MEMORANDUM: Site Groundwater Elevations in Southern Portion of Site

P.U.D. PRELIMINARY SITE PLAN
SECTION 3, T1S, R8E, CITY OF NORTHVILLE
WAYNE COUNTY, MICHIGAN

WATER TABLE DATA

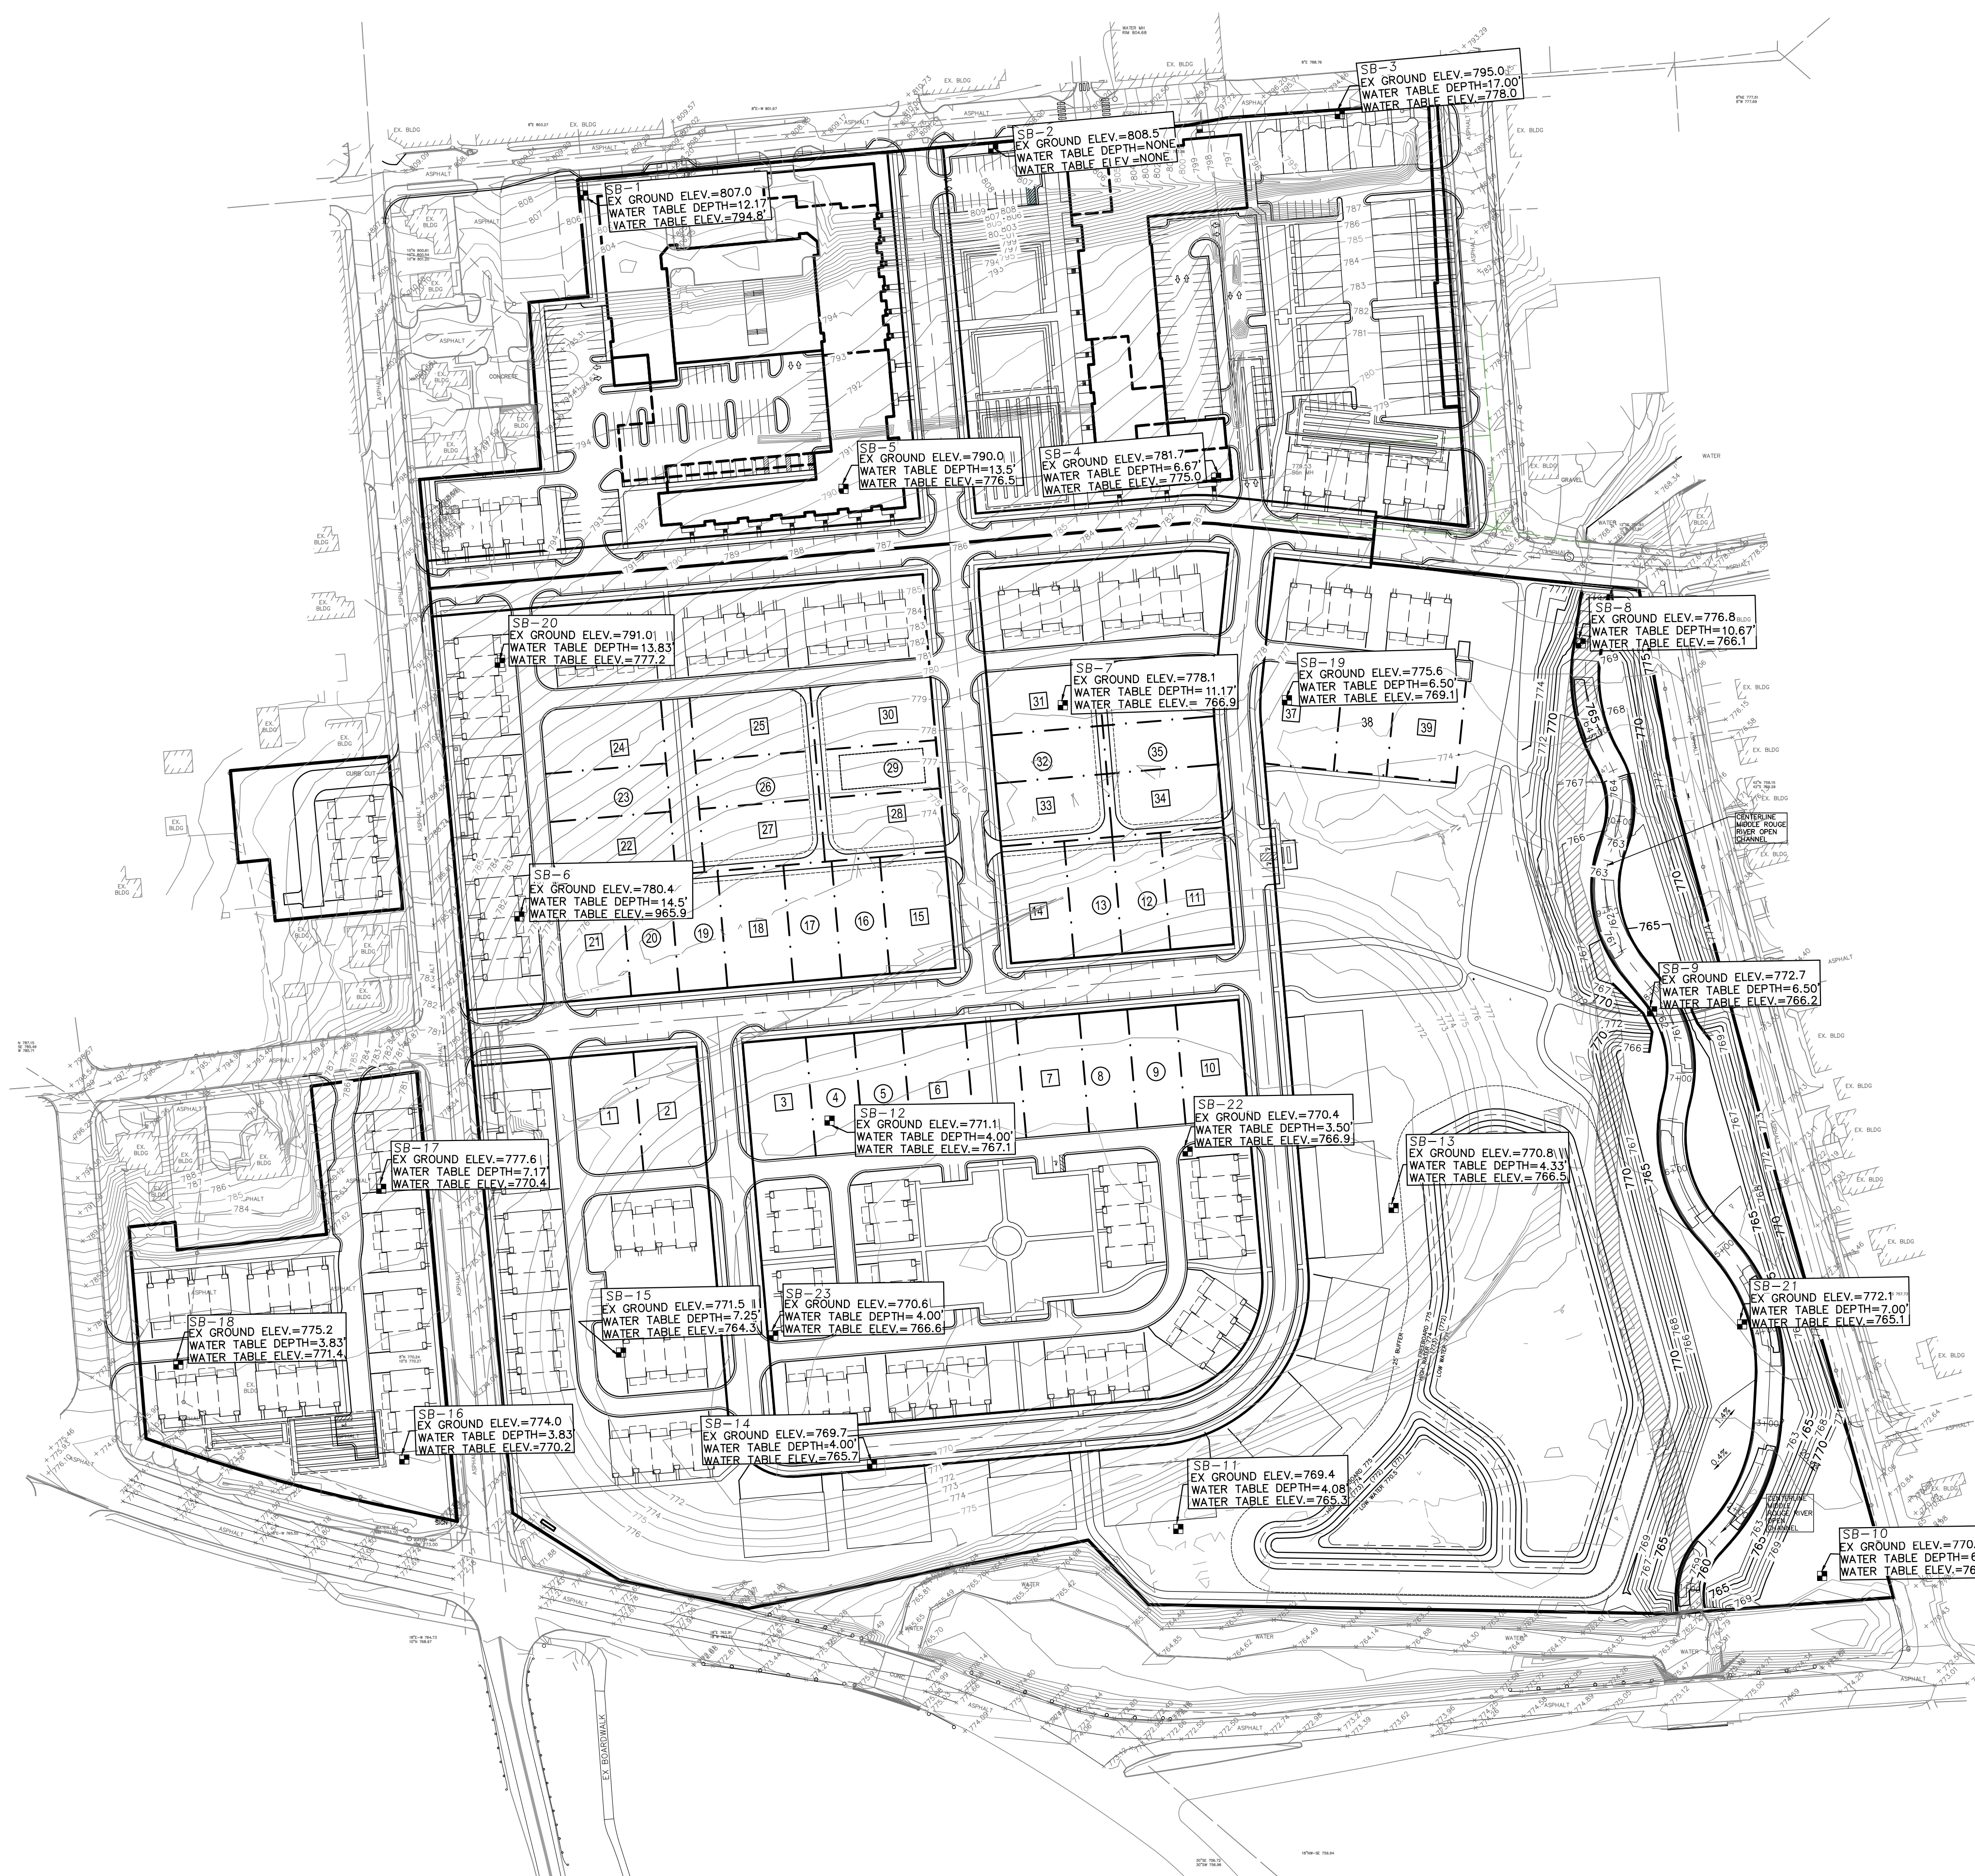
The attached sketch shows existing ground elevations and water table depths / elevations at each soil boring location. Soils boring data is taken from the soils investigations report prepared by McDowell & Associates, dated June 7, 2018.

In the racetrack area the existing ground elevation is approximately EL 770.0 to 771.0 in the middle of the track. The ground water elevation in the area is generally at EL 767.0 for a ground water depth of approximately 3-4 ft. In the area between Beal Street and Fairbrook Street, where the Single Family Homes are currently shown, the existing ground elevation is variable since the site elevations rise quickly as you move north on the site from the track area. The ground water depths in this portion of the site are approximately 11-15' deep. This portion of the site is a much better location for units with basements because basements can be installed below existing grade, limiting the amount of fill needed to final grade the site. In the racetrack area it is estimated that a minimum of 8 ft of structural fill will be required to raise the ground enough to keep the proposed basements above the existing groundwater elevation.

In the racetrack area, the groundwater elevation is approximately El 767.0. The minimum Finish Grade for a Single Family unit with a 10' basement is 779.0 - 780.0, preferable higher. This would require the proposed grade of the racetrack area to be raised approximately 8'-10' with structural fill. In order to raise the site this high, it is estimated approximately 100,000 – 125,000 c.y. of structure fill would be required at a cost of \$2.3 - \$3.0 million dollars (\$22.50 / c.y.). This fill cost is not financially feasible for this development. The racetrack area of the site should be kept as low as possible, at elevations close to existing, to limit the amount of fill required in the southern portion of the development.

SKL has discussed the basement depth and fill requirements with Mr. Nicolas Bayley of OHM. There are opportunities to lower the southern portion of the development significantly by lowering the High Water Elevation of the proposed detention basin. The road elevations and Finish Grade Elevations in the racetrack area can potentially be lowered as much as 4 ft, reducing the amount of fill and making the development financially feasible. Future Site Plan submittals will be revised to reflect this lower elevation in the southern portion of the development.
